**FINAL DRAINAGE REPORT FOR  
~~TRACT IN NE4NW4 SEC 18-14-65~~  
2601 EAST PLATTE AVENUE  
COLORADO SPRINGS, COLORADO 80916**

JULY, 2021

TERRA NOVA ENGINEERING, INC.  
721 S. 23RD STREET  
Colorado Springs, CO 80904  
(719) 635-6422

PCD Filing No.:  
MS-21-008

### EXISTING DRAINAGE MAP

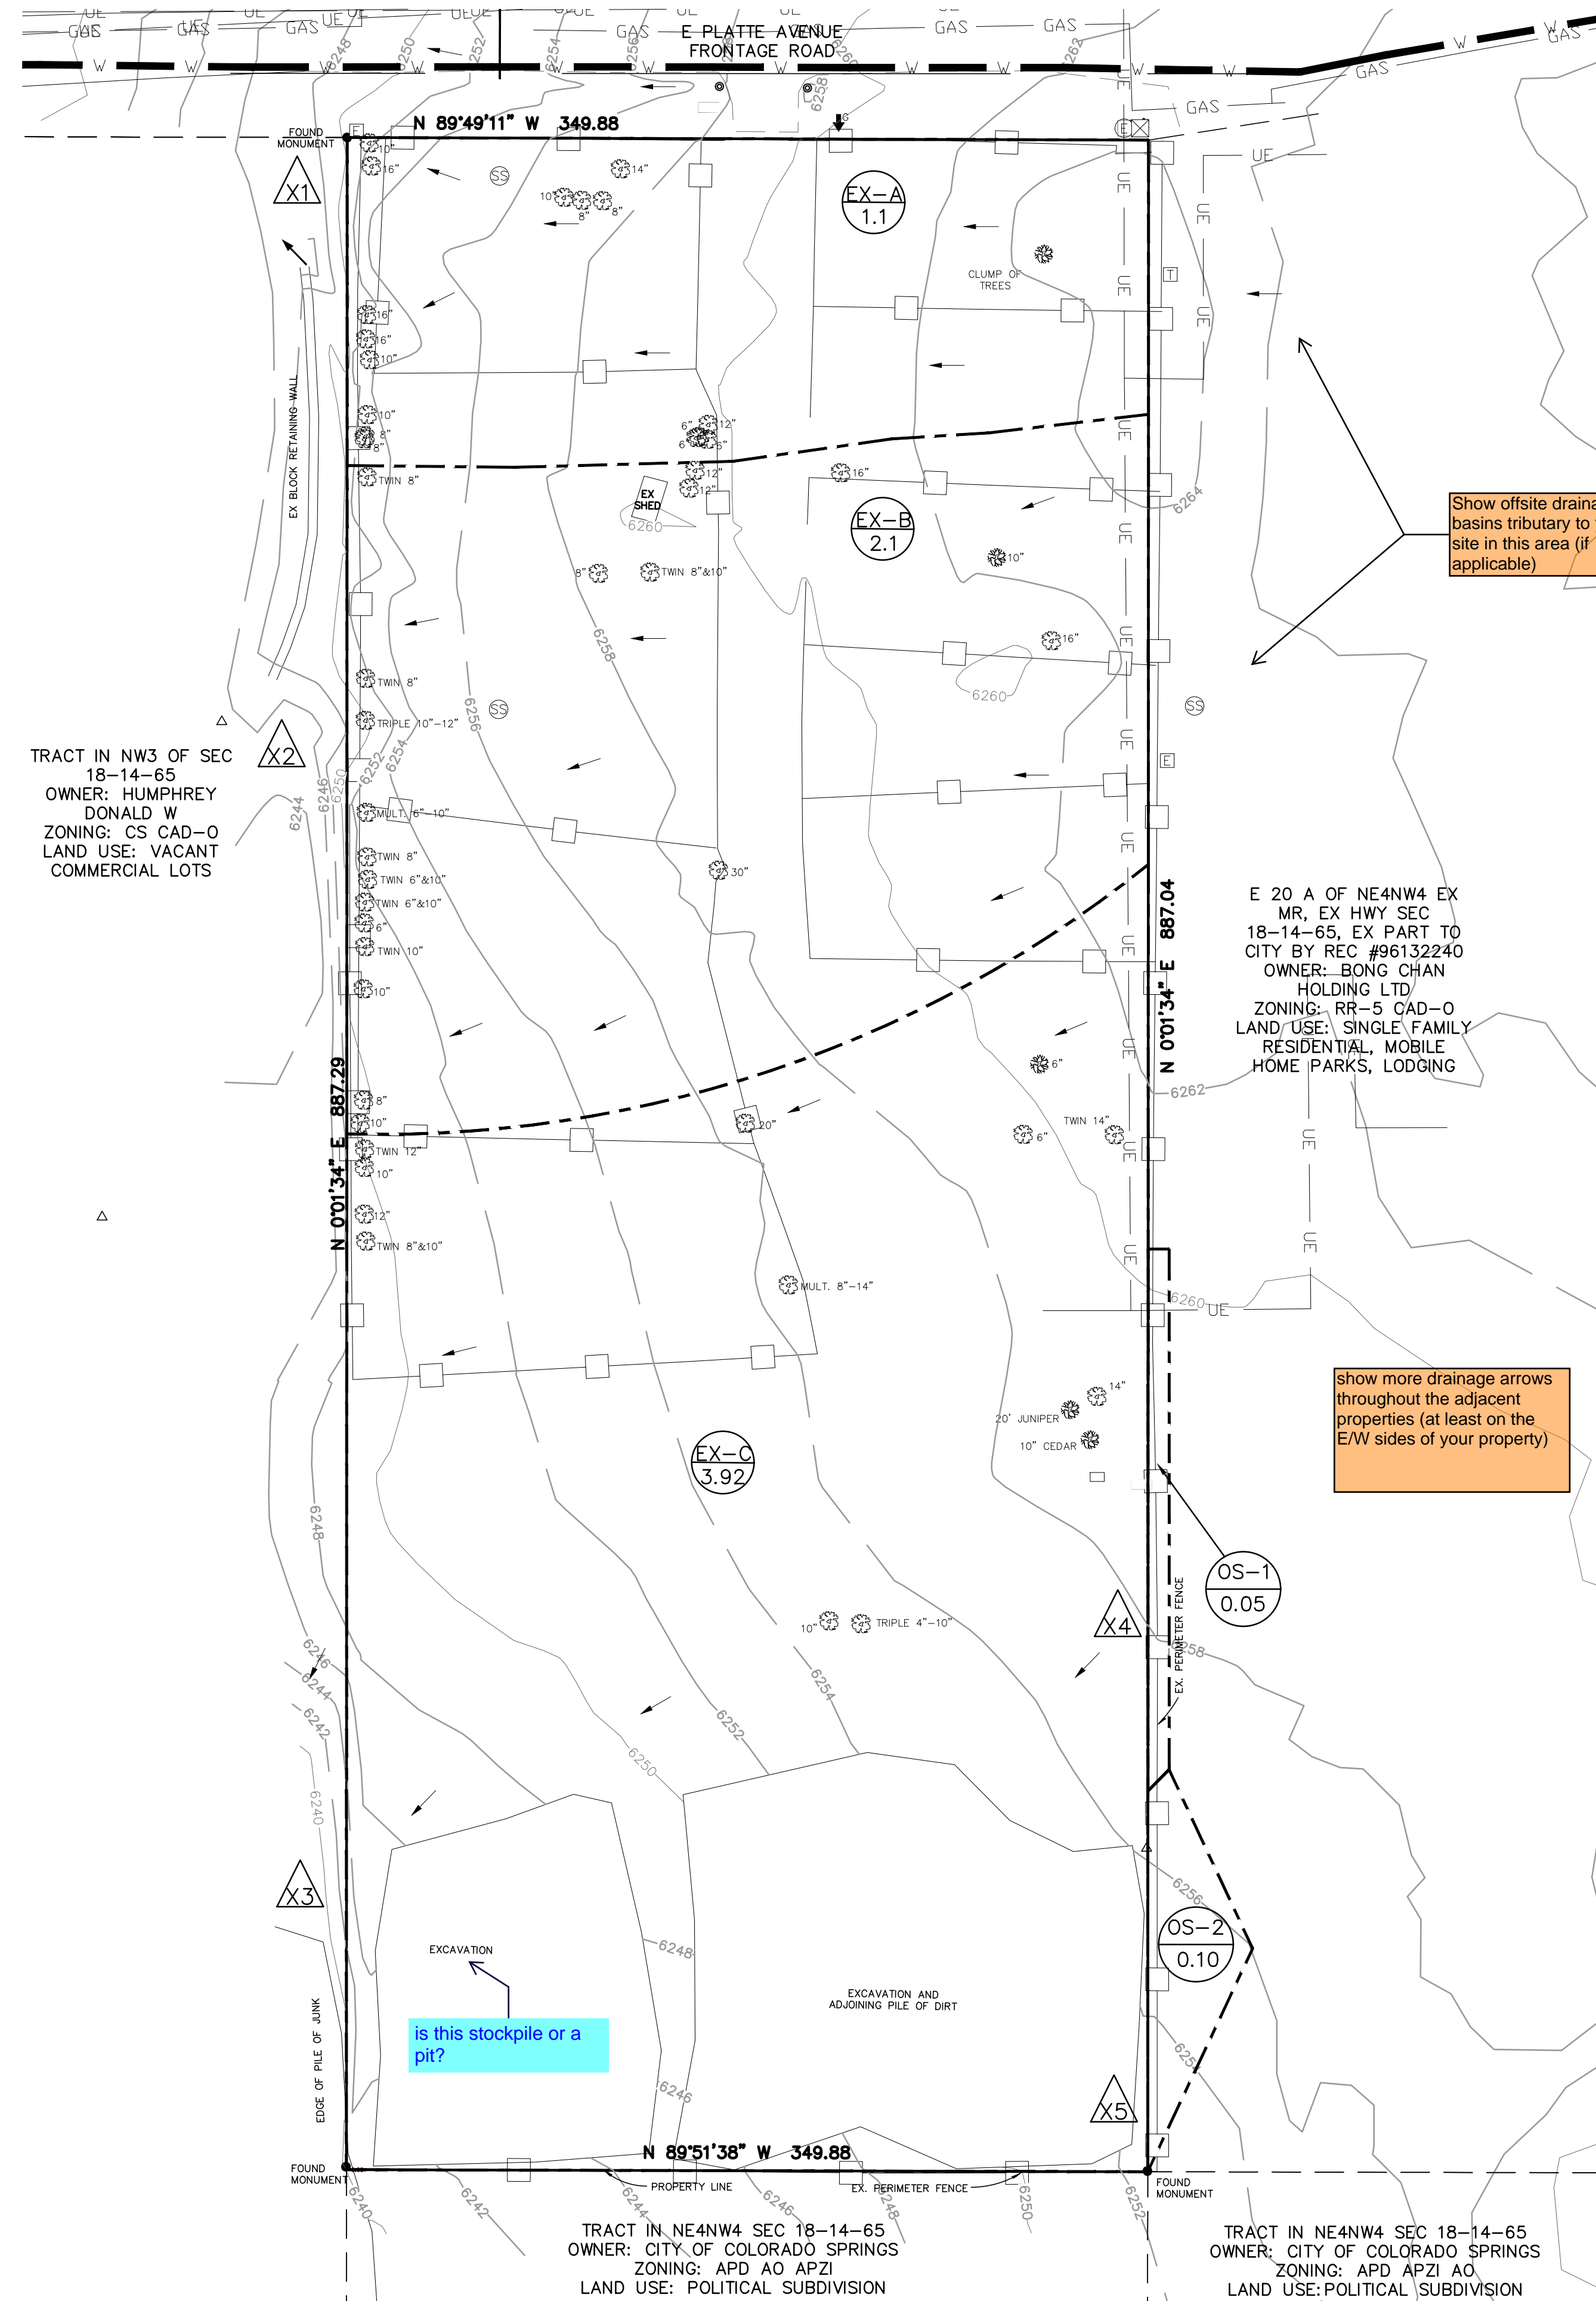
Please also detail why no runoff is conveyed from the adjacent eastern property at EX-A and EX-B. Because it appears from the drainage map that there is runoff conveyed onto the those basins from the east.

Revise to standard driveway with culvert per detail SD\_3-14. Minimum culvert size on roadside ditches is 18" diameter. Provide culvert analysis to determine if the 18" diameter culvert is sufficient

Update and include the off-site basin draining into the property

Label. Is there a curb & gutter proposed along the western property line to convey flow along the property line.

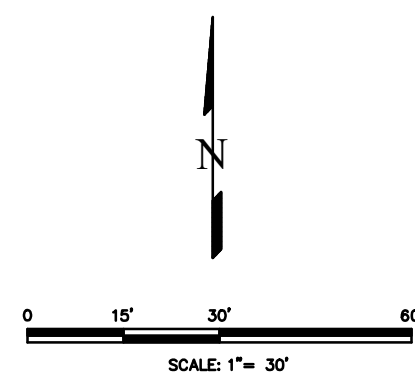
Per ECM I.7.1.A, the entire applicable development must be treated by a permanent WQ control measure.

Revise basins K and I to drain into a permanent WQ control measure or update the sub-basin narrative to identify the specific exclusion from permanent WQ control measure. See ECM appendix I Section I.7.1.B and I.7.1.C.1.a for a list of exclusions.

Provide additional analysis downstream of the pond outlet to the next suitable outfall. See ECM 3.2.4 for the definition of Suitable Outfall Location.

The nature of runoff leaving the site has changed from sheet flow in the existing condition to concentrated flow in the proposed condition.

Not enough information has been provided to show if the concentrated flow path is hydraulically adequate and will have no negative impact to downstream property.

### CONSTRUCTION DRAWINGS

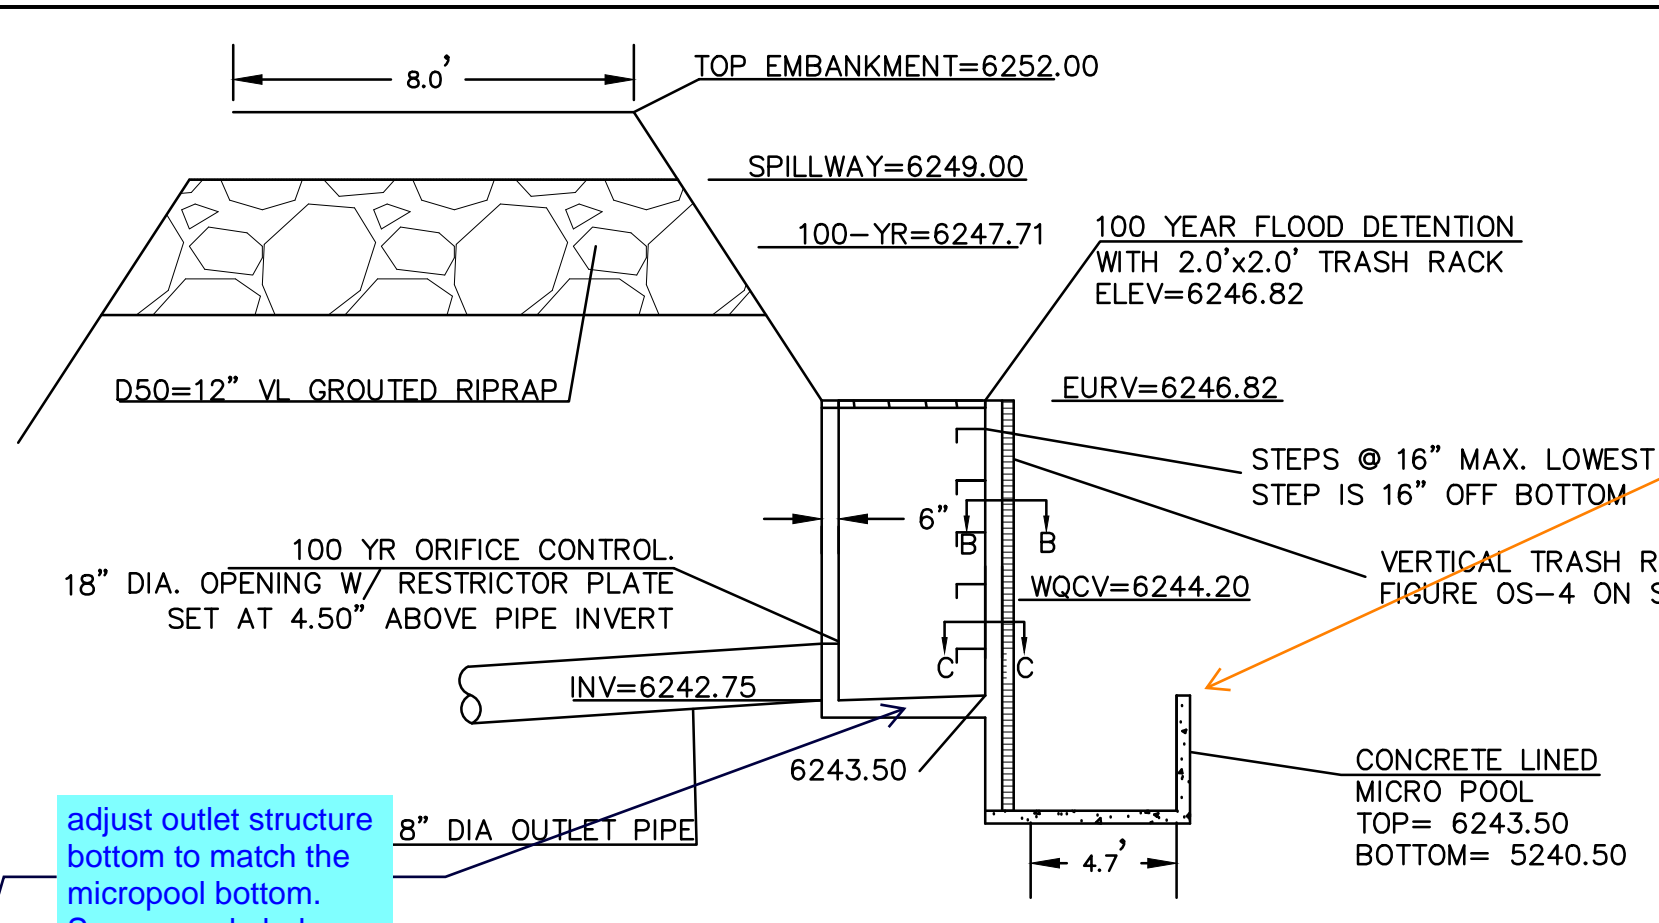
Remove Sheet.  
Redline comments are cursory comments. Detailed comments will be provided to the construction drawings as part of the review of the site development plan application.

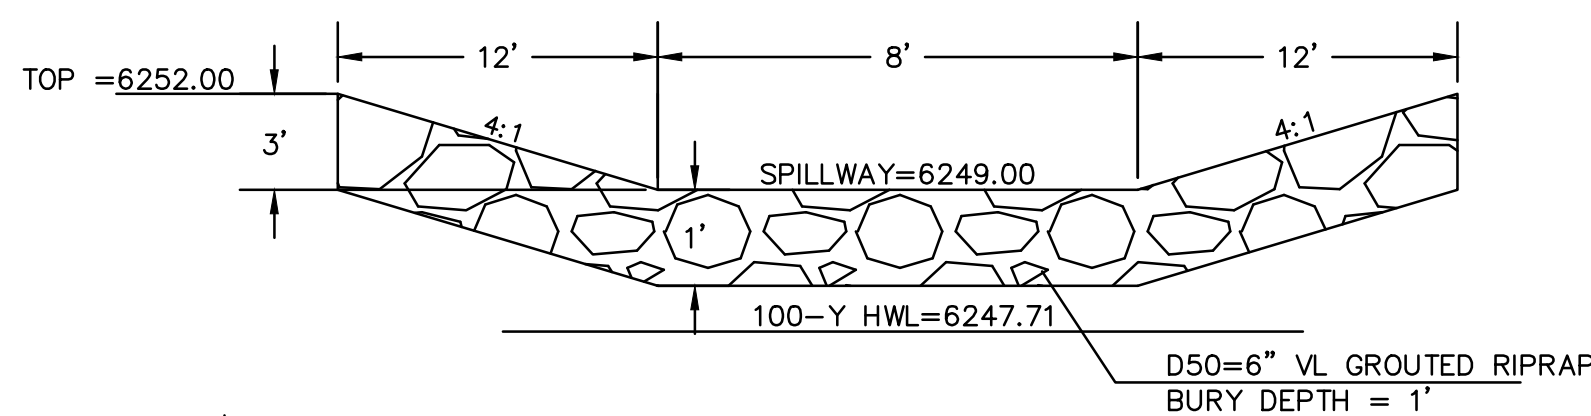
show how surrounding pond bottom will tie-in to trickle channel. And label with minimum slope of 3% per MHFD Detail T-5.

adjust outlet structure bottom to match the micropool bottom. See example below.

Show dashed line for micropool walls so it's clear if they are straight or angled walls.

Need a plan view detail of micropool.

15' MAINTENANCE ACCESS ROAD SECTION

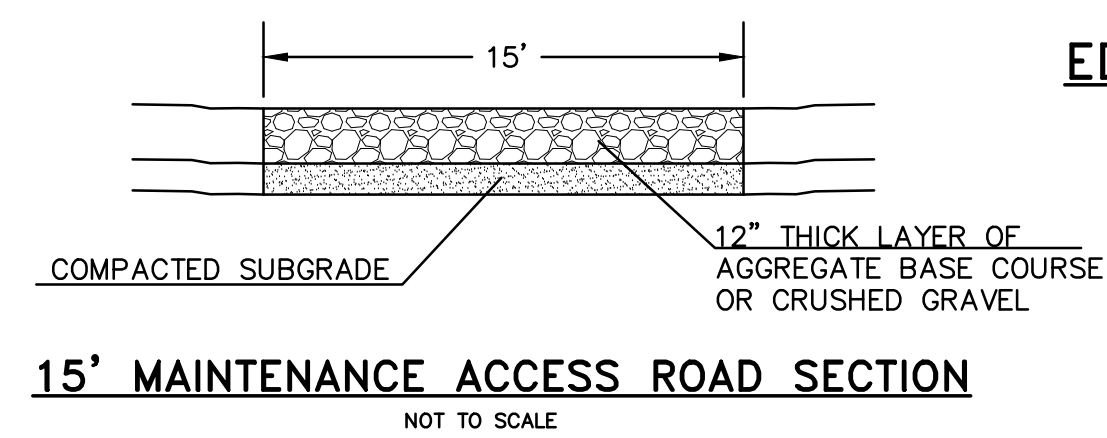
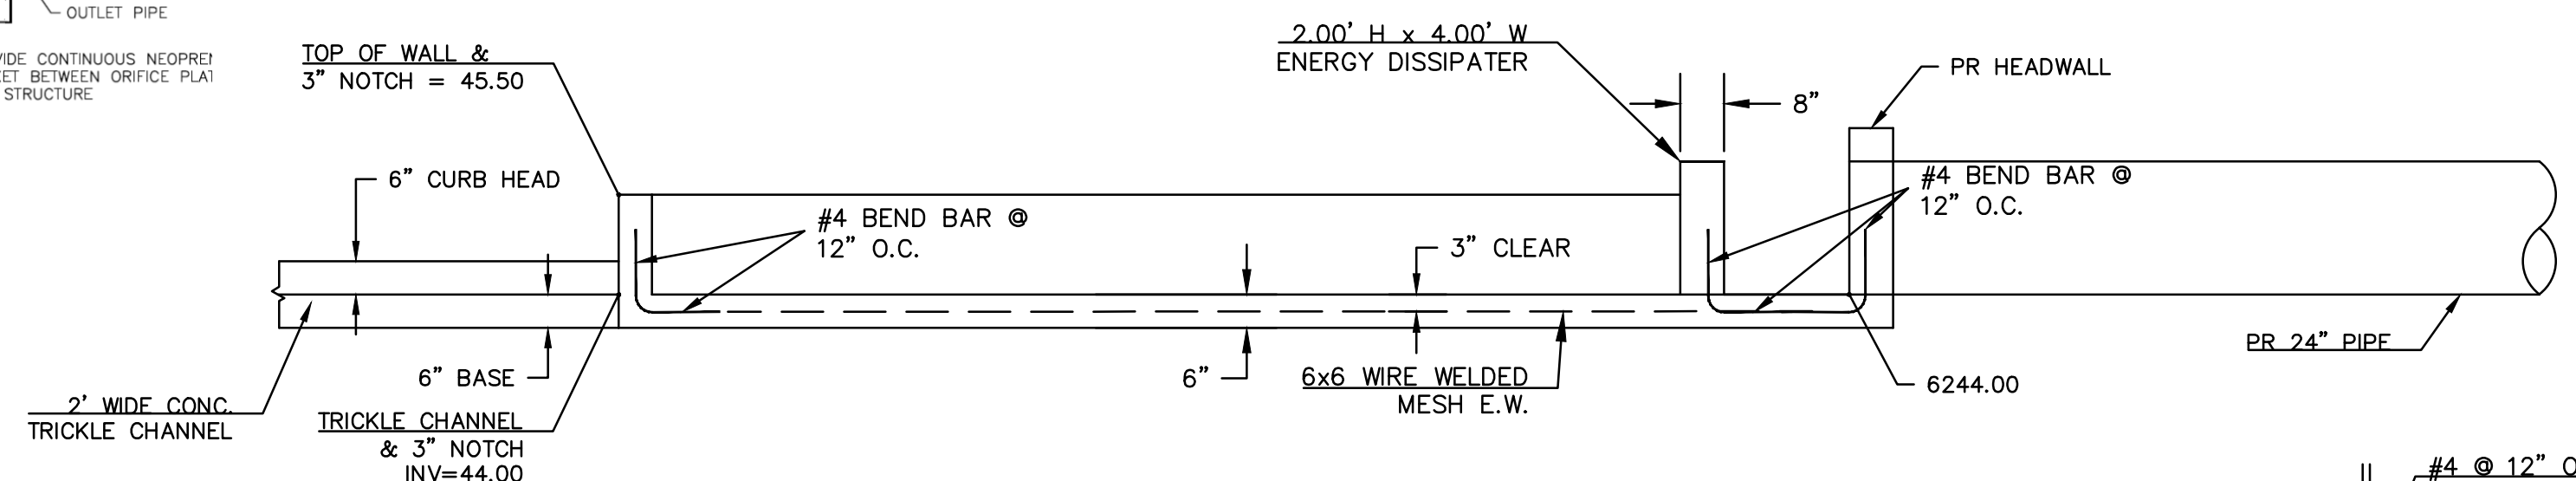
Detail on left states width = 15ft.  
Stabilized access ramp shall be a minimum of 15 ft wide and no greater than 12% slope, in accordance with DCM Vol. 1 Section 11.2.2  
-Unless the anticipated maintenance vehicles and equipment can safely access the pond at specified road width. Properly document this in the Pond O&M manual.  
Revise as needed.

SECTION C-C

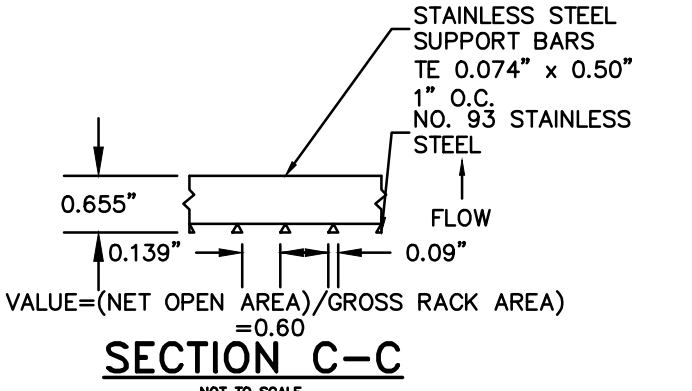
note that from the UD-Detention sheet, the units related to these values is square inches. Revise drawing (for site development plan submittal).
